SUBDIVISION REPORT - CONCEPT

► **FILE #:** 7-SB-21-C

► **SUBDIVISION:** CAPITAL DRIVE

► **Postpone the Concept Plan application until the August 12, 2021, Planning Commission meeting as requested by staff for the reasons listed below. (The applicant is requesting approval of the Concept Plan and a variance to reduce the Kingston Pike right-of-way from 50-FT to 44-FT).**

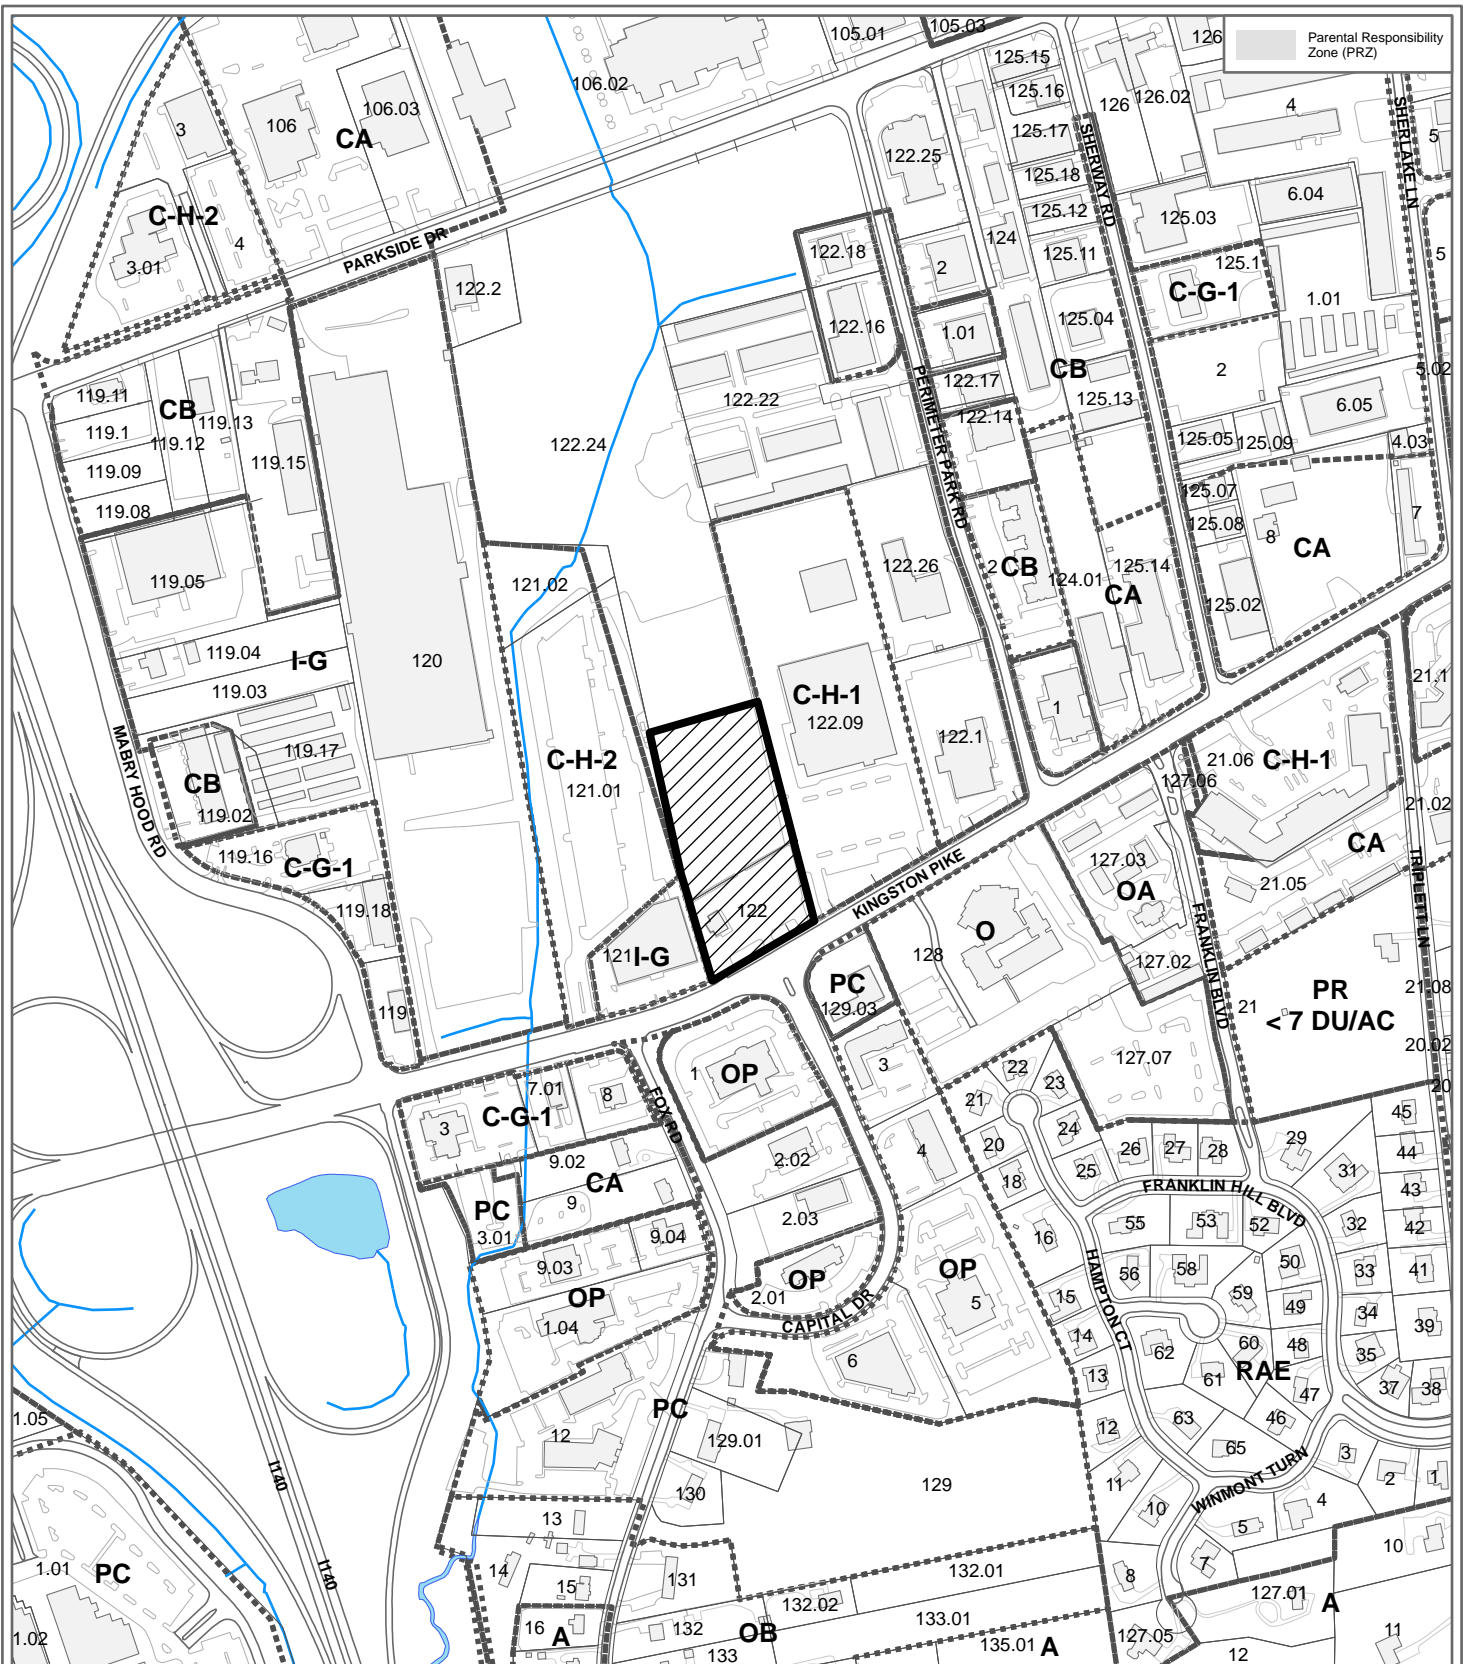
1) Show all major recommendations of the Capital Drive-Kingston Pike Retail Development Traffic Impact Study (CDM Smith, revised June 21, 2021) on the concept plan (see Exhibit A), including the reconfiguration of the northbound approach on Capital Drive.

2) Correct the right-of-way and curb radii at the intersection of the new road and Kingston Pike. The minimum radii in commercial and industrial zones at intersections is 75-FT, however, this can be reduced to 50-FT with

the approval of City or County Engineering. The proposed radii appear to be 25-FT which would require approval of a variance by the Planning Commission.

- 3) Removal of the westbound acceleration lane for vehicles turning right from the new road onto Kingston Pike.
- 4) Provide a preliminary detention pond plan for Lot #4 to demonstrate that the modified parking lot for the existing retail store (GemStore) can feasibly remain in compliance with the zoning standards.
- 5) Show a sidewalk along the Kingston Pike frontages of lots 1 and 4.
- 6) Provide either a 5-FT sidewalk with a 2-FT planting strip or a 7-FT wide sidewalk along the new road. The proposed sidewalk has a width of 5-FT without the planting strip.
